AGENDA CITY OF SALIDA PLANNING COMMISSION

1. Major Impact Review – River Ridge Major Subdivision - The request is for Major Impact Review of a Major Subdivision for River Ridge Subdivision consisting of 41 lots on 9.06 acres located on Scott Street, 500 feet north of CR 105 (Old Stage Road). The property is zoned R-3 and R-4.

PLANNING COMMISSION STAFF REPORT

RE: River Ridge Subdivision Plan review comments

SHEET NO. RIVER RIDGE SALIDA, CO 13 SEWER PLANS OF_{OF} SHTS. SEWER DETAILS PROJECT NO. **DETAILS** 18031

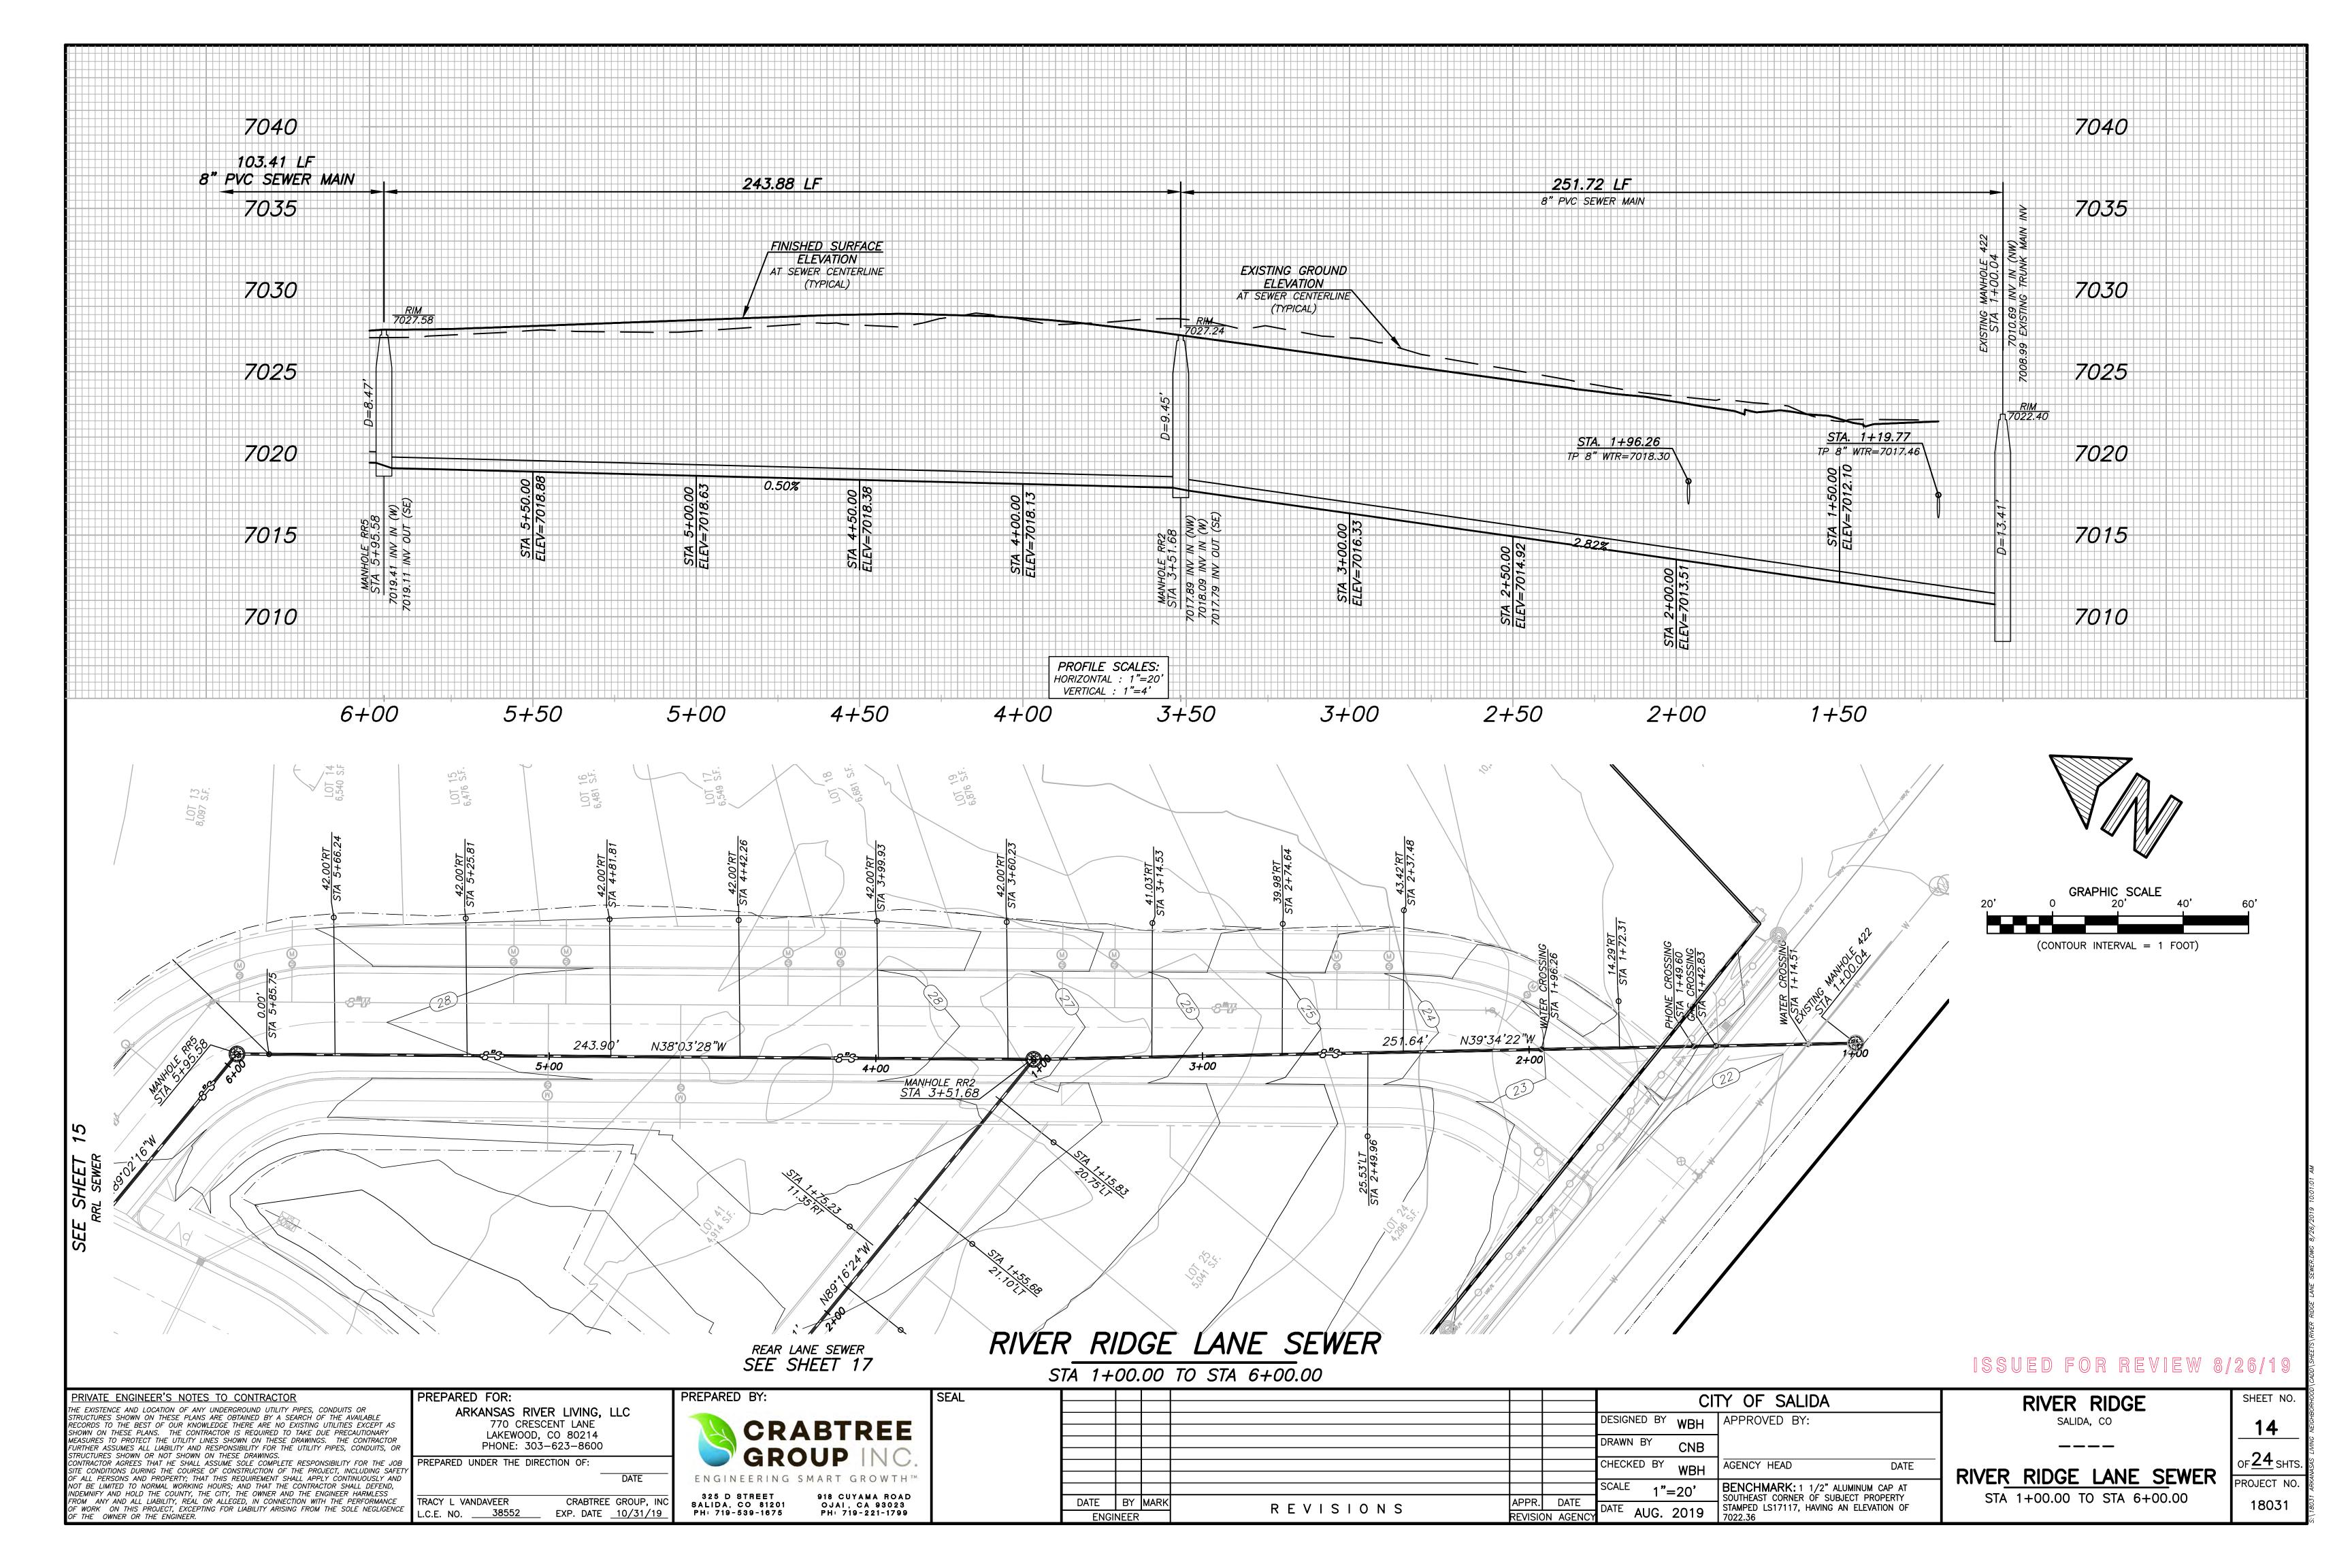
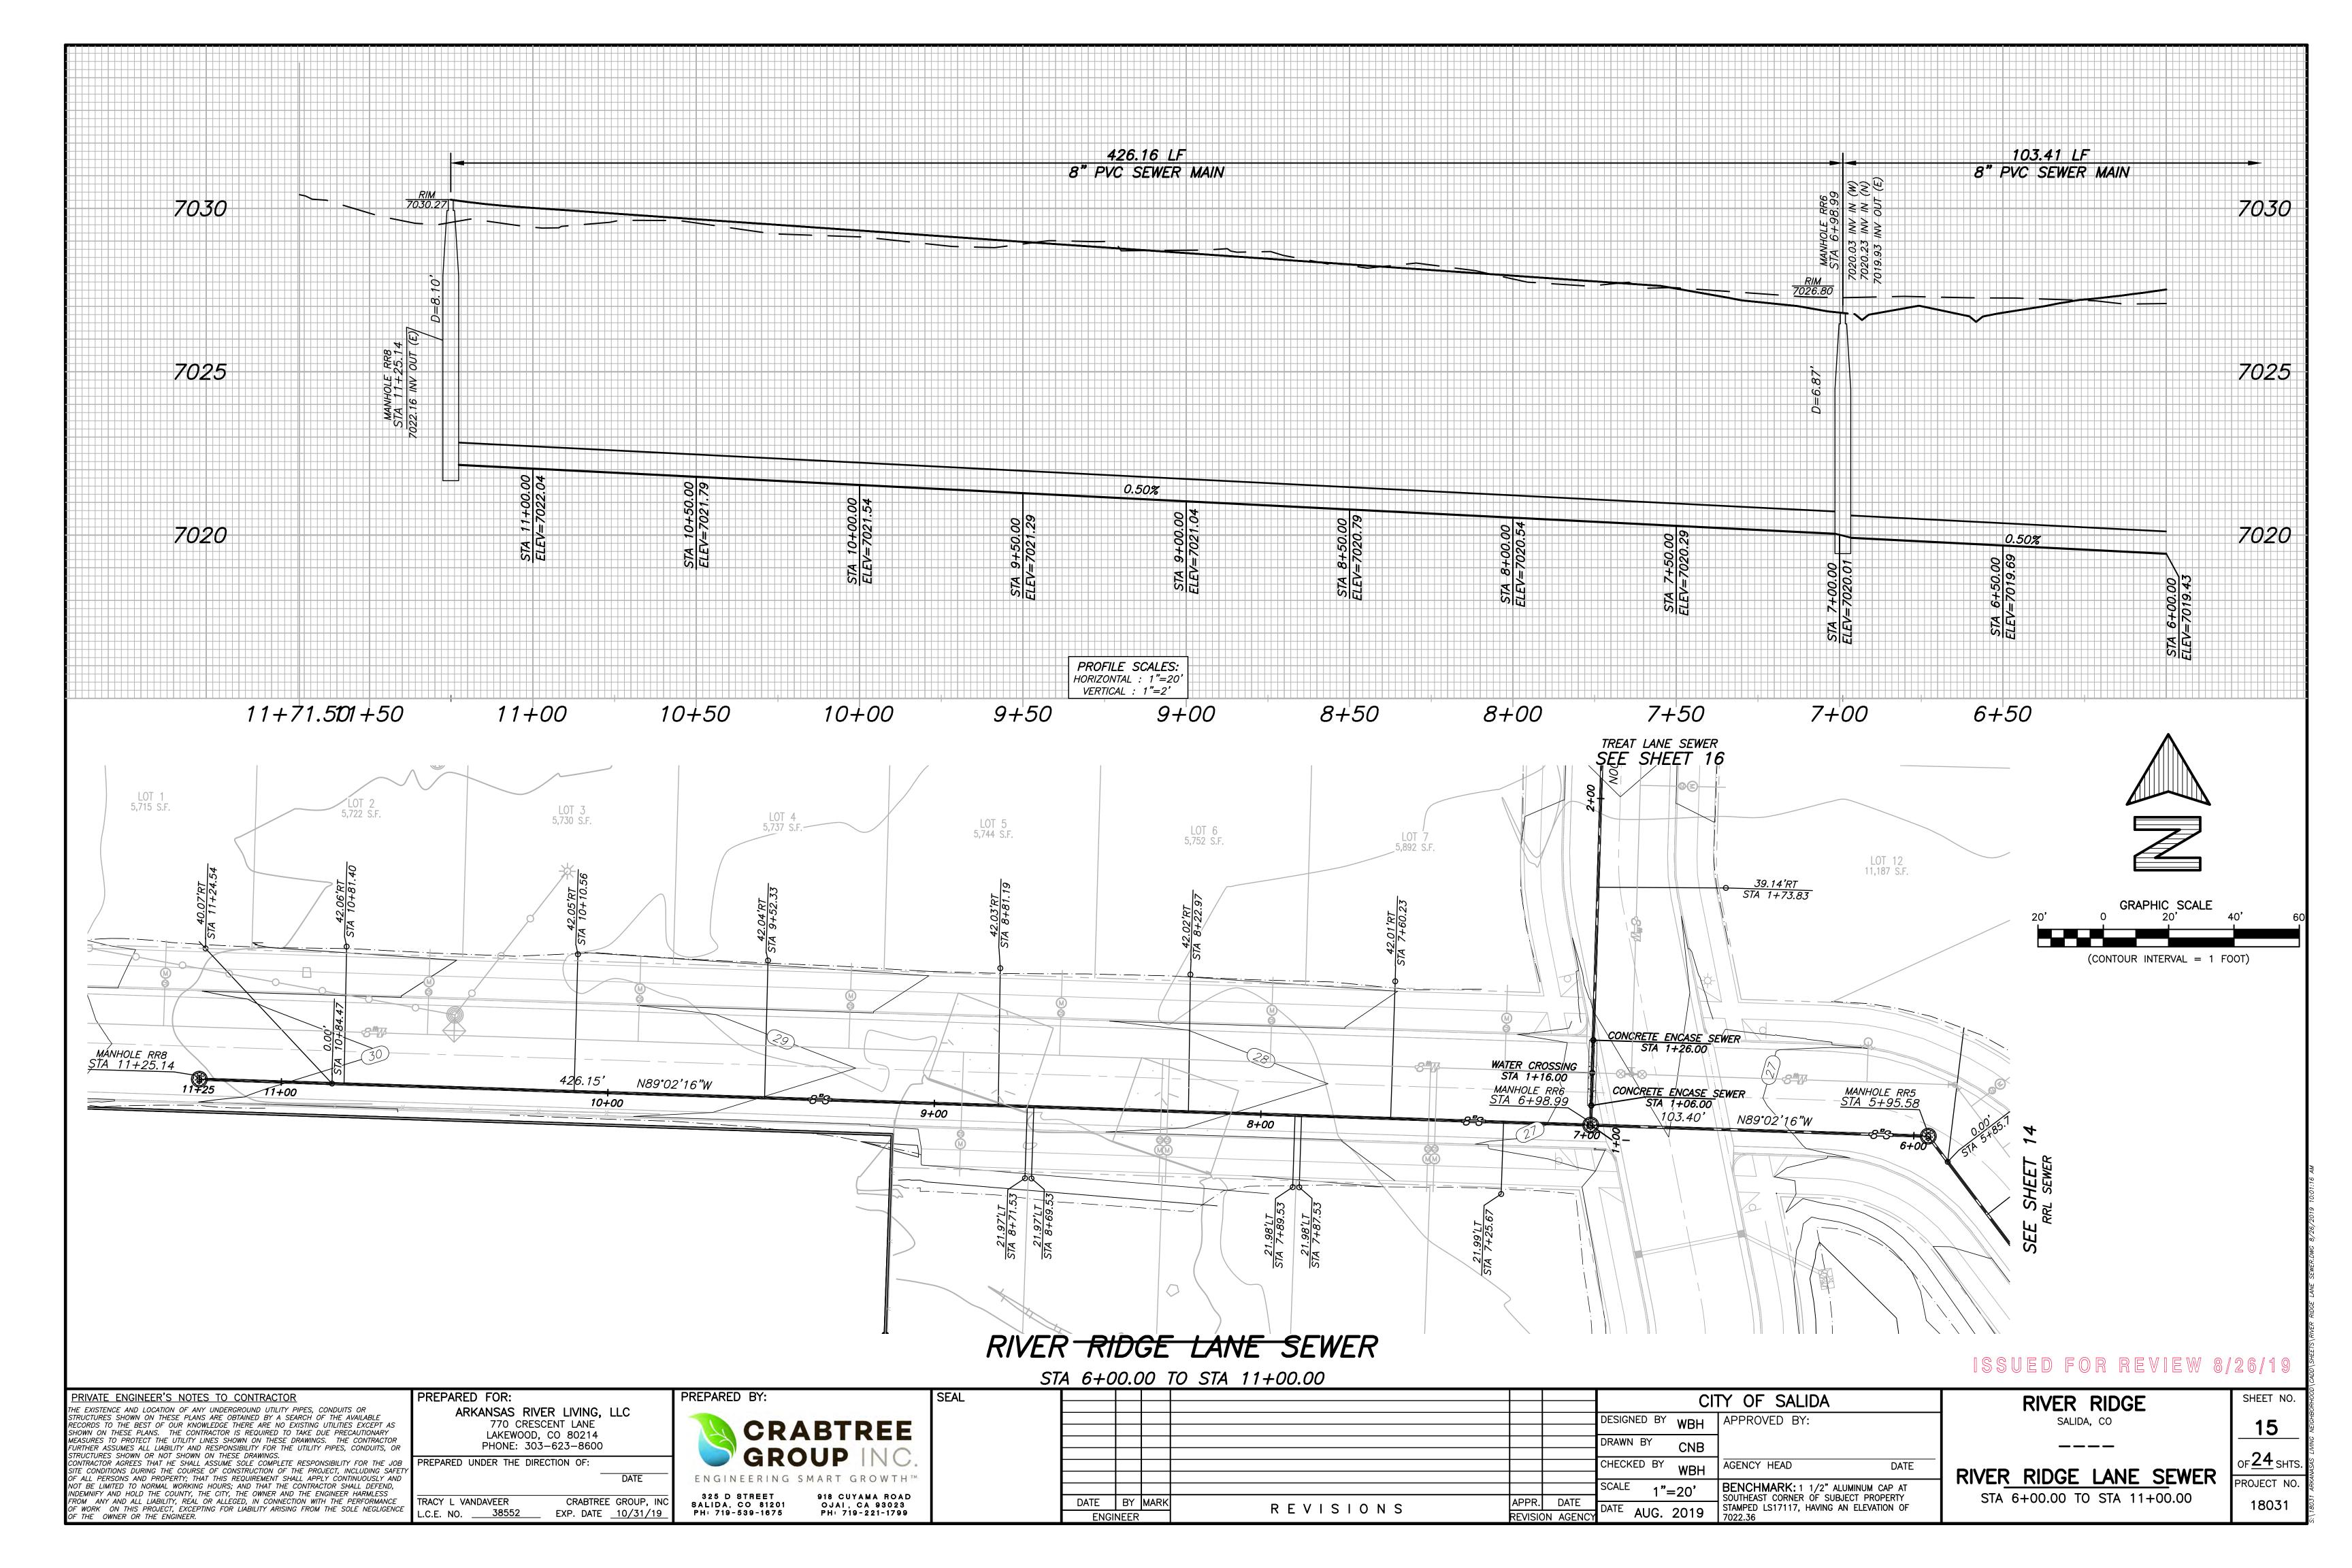
- 9. Sheet numbers on sewer index sheet need corrected.
- 10. Identify Tie-In Manhole as MH-17D. Note 'Core Drill Existing Manhole and Grout with Non-Shrink Grout.' (SH-14)
